Technical Service Bulletin

GROUP	NUMBER
CAMPAIGN	23-01-040H
DATE	MODEL(S)
APRIL 2023	NEXO (FE)

SUBJECT: HMU UPDATE & PRESSURE RELIEF VALVE (PRV) REPLACEMENT (SERVICE CAMPAIGN T9A)

This TSB supersedes 22-01-080H to increase Hydrogen fuel sublet from \$100 to \$150.

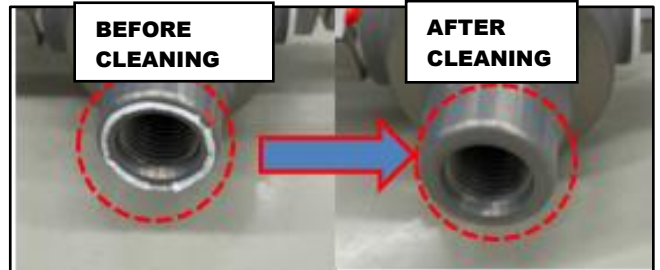
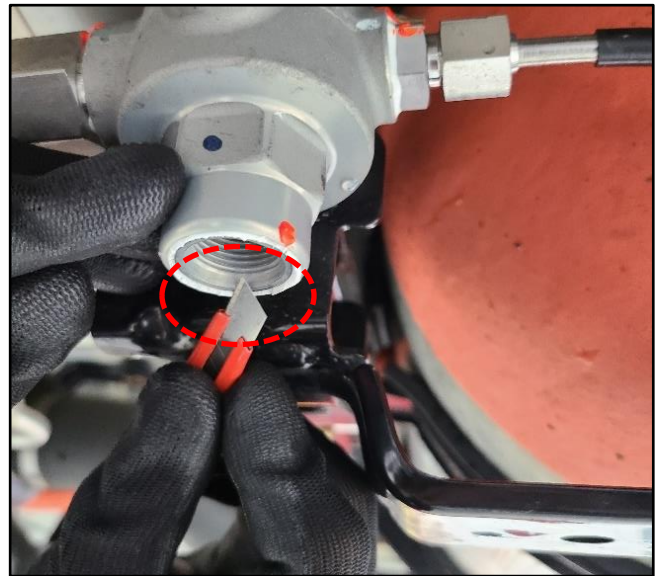
9. Remove the pressure relief valve (PRV) (A) using a 24mm socket & ratchet. Turn the PRV counterclockwise to remove. Use a 32mm wrench to hold the Regulator while removing the PRV.

10. Remove the PRV sealant using a razor blade.

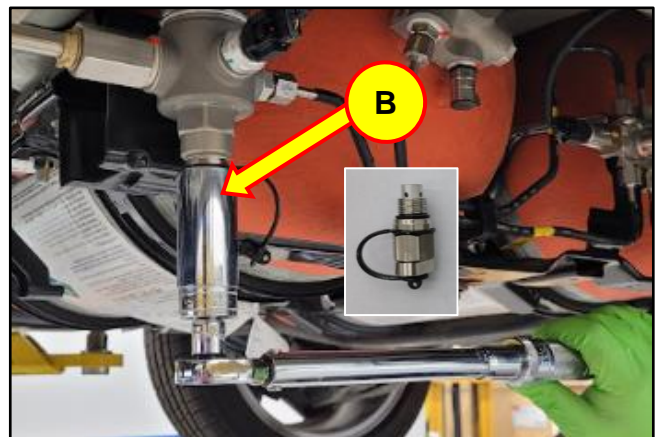
11. Install the new PRV (B) turning it clockwise.

Tightening Torque:
 54.2 ~65.8 lb-ft (73.5~89.2 Nm)
